Title		PIXRACER-V1-IMU	AUAV.CO
Size	Number	JAN-21-2016-2130	Revision RC14
Date:	21.01.2016	Sheet of	5 of 5
File:	F:\fwdsch\PIXRACER-IMU-R14.SchDoc	Drawn By:	Nick Arsov

Title			PIXRACER-V1-SD-USB-CAN-I2C	AUAV.CO
Size	Number	Revision		
A4	JAN-21-2016-2130	RC14		
Date:	21.01.2016	Sheet of	4 of 5	
File:	F:\fwdsch\PIXRACER-SD-USB-R14.Sch	Drawn By:	Nick Arsov

Title		PIXRACER-V1-SERIALS		AUAV.CO	
Size	Number	JAN-21-2016-2130		Revision	RC14
Date:	21.01.2016	Sheet of 2 of 5		Drawn By: Nick Arsov	
File:	F:\fwdsch\PIXRACER-SERIALS-R14.Sch	Sheet of 2 of 5		Drawn By: Nick Arsov

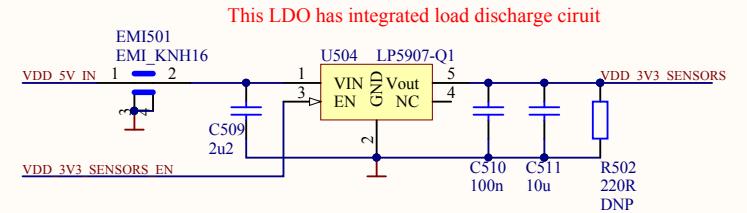
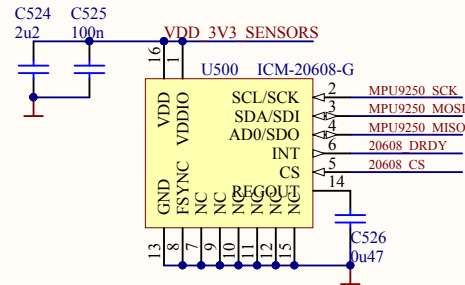
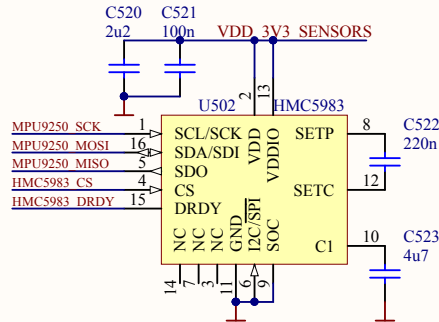
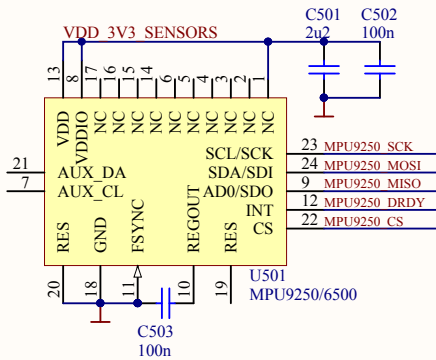
THE INTEGRATED PULL-DOWN
DISABLES THE VDD_3V3_SENSORS AT POWER ON

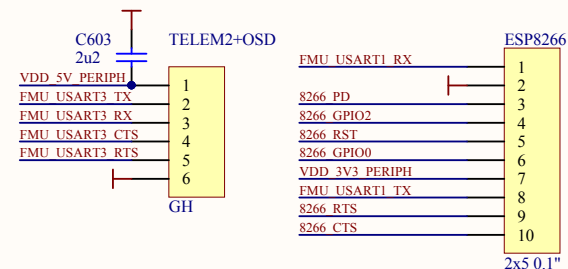
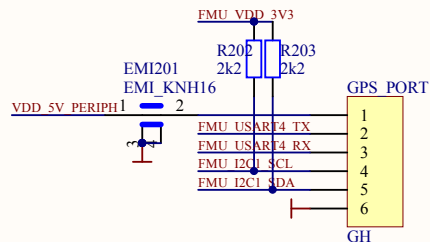
RC_INPUT is for any of PPM/SBUS/SPEKTRUM

U1203 and R200 (DNP) footprints are left as is, thus the stencils won't be changed

R200 will not be soldered, and U1203 and U1202 are left the same for lower price
